INITIAL FIRE SAFETY INSPECTION REPORT

KNIT CONCEPT LIMITED

RSC ID:11551

Date: 09-Mar-2025

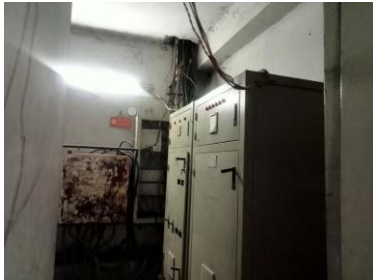
F-08	Means of Egress	<p>Electrical panels were located in the exit stair enclosure.</p> <p>Location: Stair-3 (4th Floor) of Factory building..</p>	<p>Remove and re-locate all electrical panels and water pumps from exit stair enclosures.</p> <p>Or,</p> <p>Provide fire separation with stair enclosure in accordance with section 6.3.1 of RSC Technical Guidelines (Standard)¹ V1.0.</p>	Within 3 months

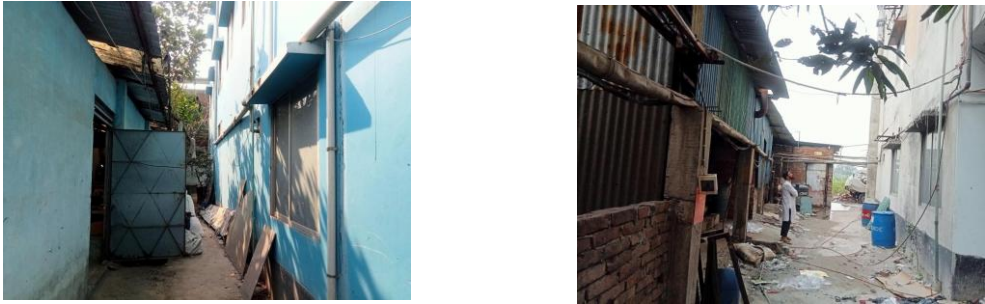
F-14	Fire rated construction	<p>Transformer is not properly separated by fire rated construction with other Occupancies/Areas.</p> <p>Location: Ground floor of Factory Building</p>	<p>Oil filled transformer shall be separated from other occupancies by a minimum 2-hr fire rated construction (wall, floor, slab etc.). Switch gears and transformer bays shall be separately housed with a 2-hr rated wall in between. Seal all penetrations and openings (door, window etc.) should be protected by 1.5-hr fire rated materials to maintain the fire separation if required. All exhaust systems shall discharge to the exterior of the building in a safe location.</p> <p>Oil filled transformers shall not be housed above ground level.</p> <p>Or,</p> <p>Relocate it to exterior of the building and maintain a minimum 3m (10 ft.) spatial separation distance from the building. Transformer room separation shall meet section 3.4.2.1.4 of RSC Technical Guideline (Standard).</p>	Within 3 months
